ENGINE - LP COMPRESSOR - ENLARGE THE HOLE DIAMETER OF THE FAN CASE REAR EXTENSION -
CATEGORY CODE 4 - MOD.ENG-72-0226

V2500-ENG-72-0226

Rework of the Fan Case Rear Extension
Fig.1

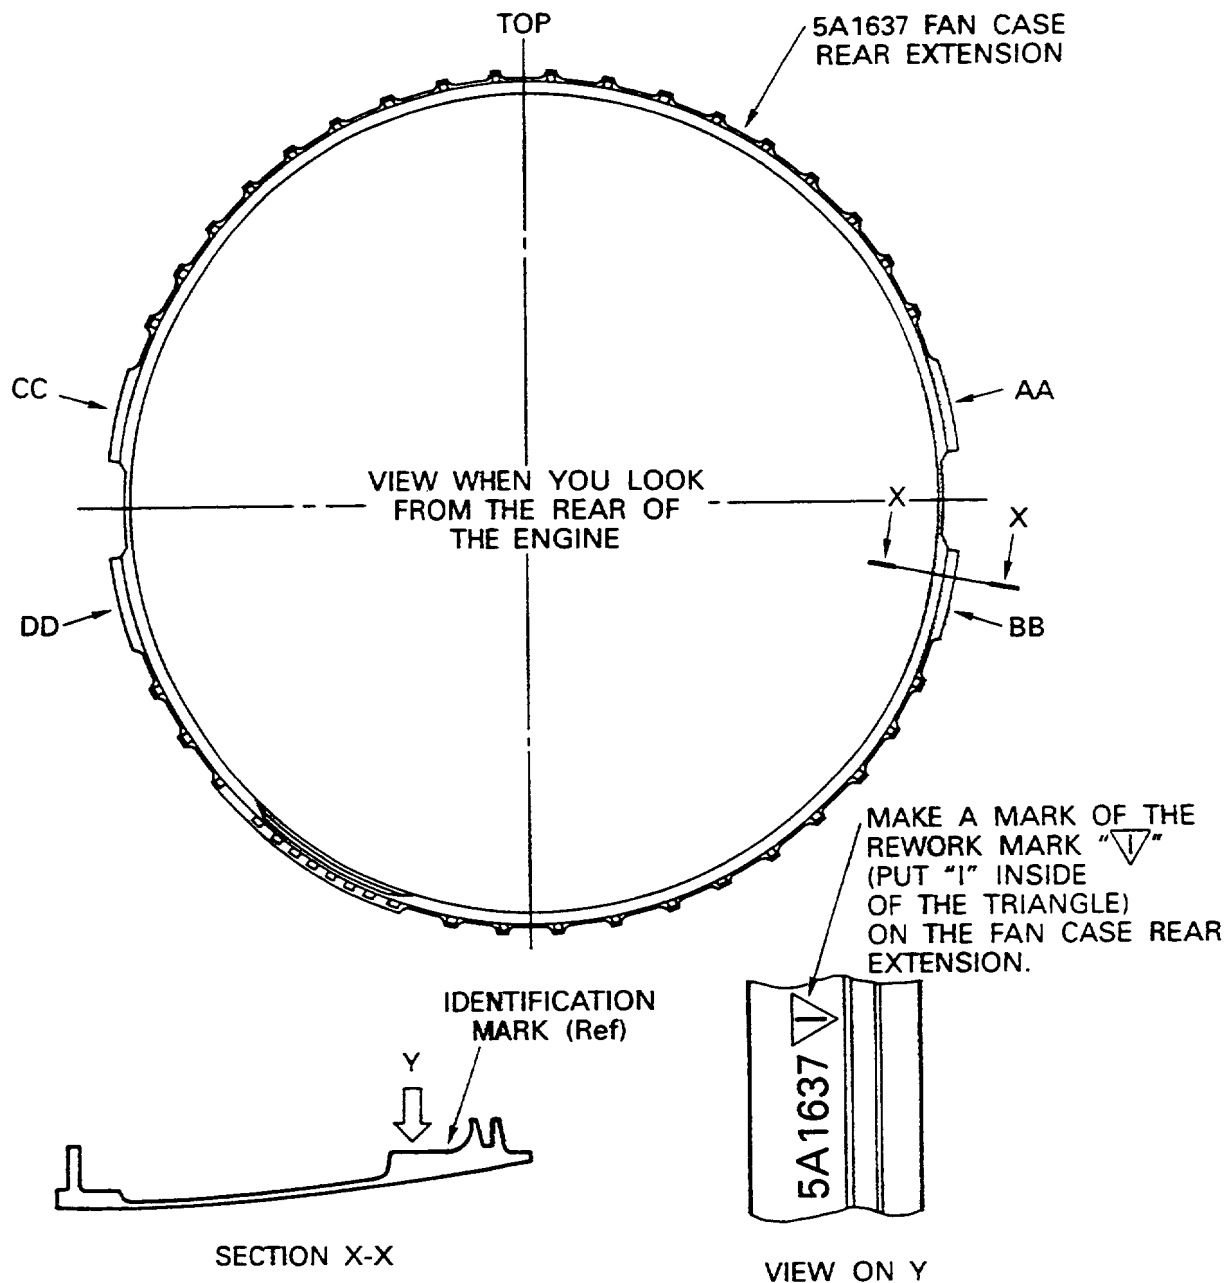
- (a) Find the 16 holes which are to be enlarged on the fan case rear extension.
- (b) Put the applicable covers on all of openings.
- (c) Clean the 16 holes
- (d) Machine the holes in accordance with following methods;
(You can select the following two methods)

| (g) Make a mark of the Rework Mark adjacent to the identify marking area. | See Figure 1 and Reference (2), Control No./ TASK 70-09-00-400-501, Marking of Parts. |

Rework of the Fan Case Rear Extension
Fig.2

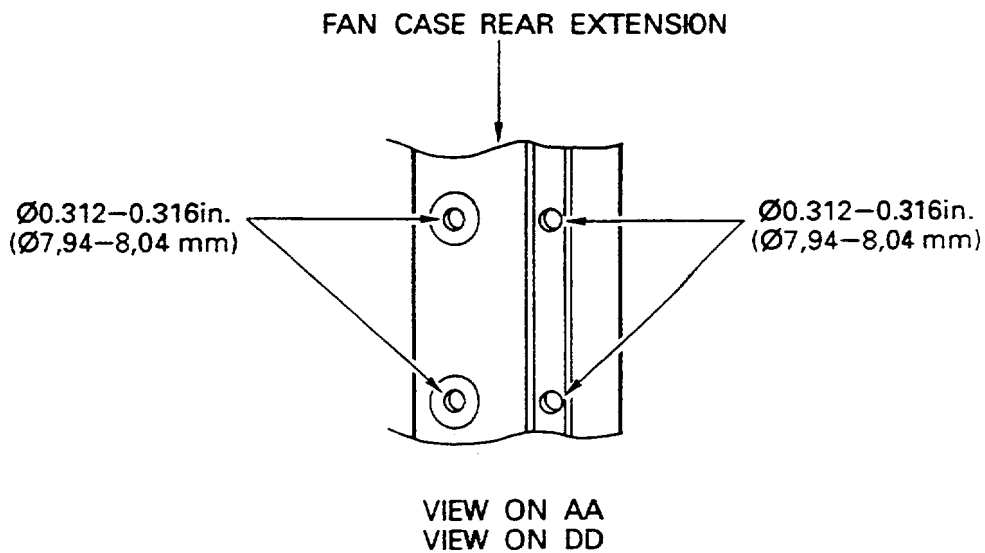
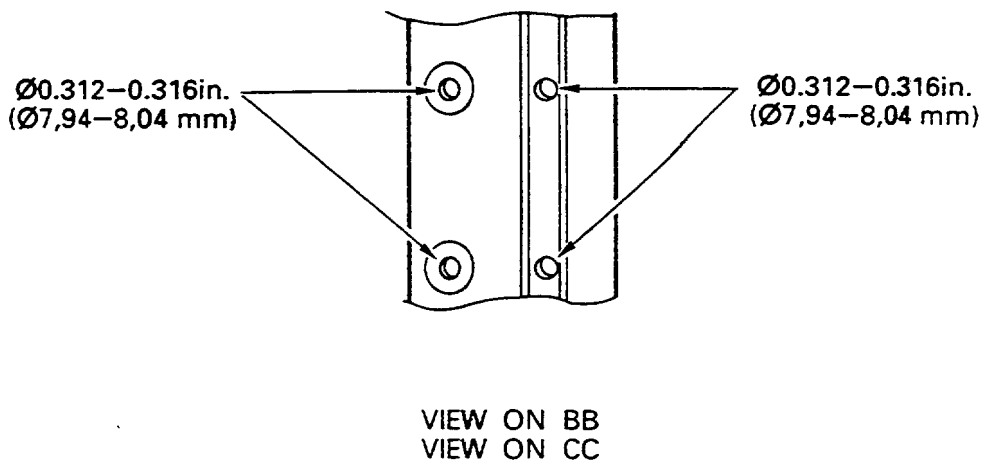
NOTE: Diameter of the enlarged hole shall not exceed 0.316 in (8,04 mm).

See Figure 2.
Measure the dimension and ensure that the edges are smooth.

| (j) Examine. | See Figure 2.

Measure the dimension of the enlarged holes. |
